SAFETY RECALL

CERTAIN 2021 ~ 2022 1190 RX and SX MODELS

FACTORY MODIFICATION CAMPAIGN – Incorrect Index Spring Placement

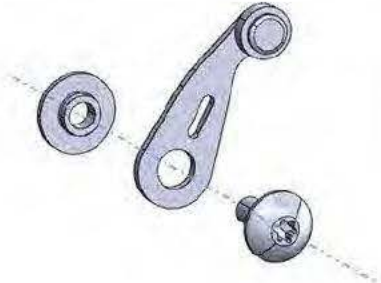
Buell Motorcycle Company ("Buell") has decided that a defect which relates to motor vehicle safety exists in certain 2021 ~ 2022 1190 RX and SX motorcycles. In affected motorcycles, the index spring for the gear shift shaft may be improperly installed. If the index spring is improperly installed, it could be difficult to shift gears, which could result in loss of control and a crash with injury or death.

To correct this defect, Buell is initiating a NHTSA Recall Campaign. Affected units must have the index spring position corrected with a new bolt and other kit contents.

Part Name	Incorrect Orientation	Correct Orientation
<i>Spring, Index (CG0003.1B7)</i>	 <p data-bbox="764 852 927 884">Behind Boss</p>	 <p data-bbox="1208 852 1409 884">In Front of Boss</p>
Assembly	Incorrect Order of Assembly	Correct Order of Assembly
CAUTION: Please ensure the washer is assembled behind the shift lever as pictured	 <p data-bbox="646 1346 1047 1377">Washer between Lever and Bolt</p>	 <p data-bbox="1175 1356 1446 1388">Washer behind Lever</p>

Refer to the Index Spring Orientation Instruction to reinstall the index spring found <https://buellmotorcycle.com/support>.

After modifying a unit, make sure to properly record and submit the special warranty claim for this safety recall to ensure correct reimbursement and to update the unit's repair history in Buell's database.
The correct placement can be identified by:
